NLS2004099
October 25, 2004

Subject: License Amendment Request to Revise Technical Specifications - Safety Limit
Minimum Critical Power Ratio
Cooper Nuclear Station, Docket 50-298, DPR-46

License Amendment Request to Revise Technical Specifications
Safety Limit Minimum Critical Power Ratio

Cooper Nuclear Station, NRC Docket 50-298, DPR-46

Figure 1
Reference Loading Pattern – Cooper Nuclear Station Cycle 22

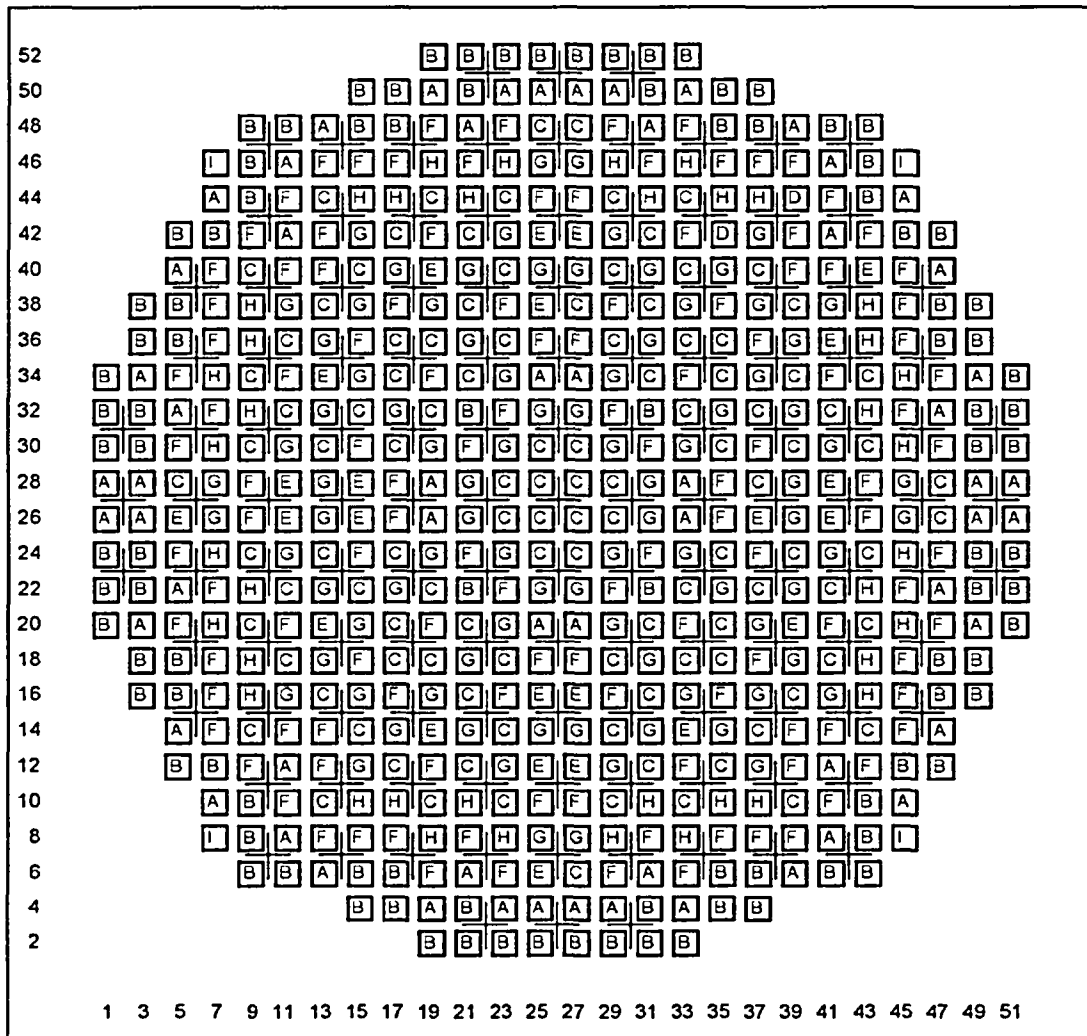
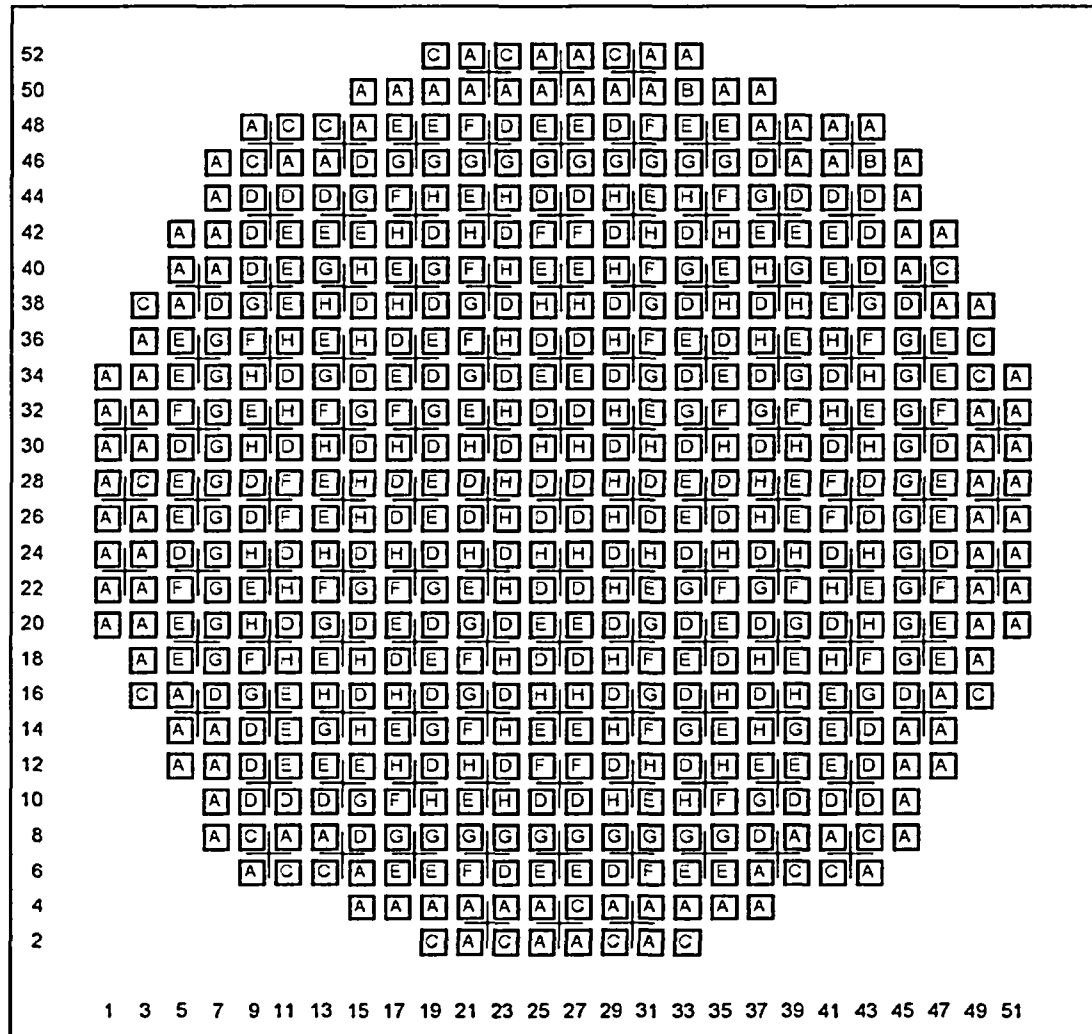
The core loading information for Cooper Nuclear Station Cycle 22 is provided in Figure 1. For comparison the core loading information for Cooper Nuclear Station Cycle 23 is provided in Figure 2. The impact of the fuel loading pattern differences on the calculated SLMCPR is correlated to the values of [[
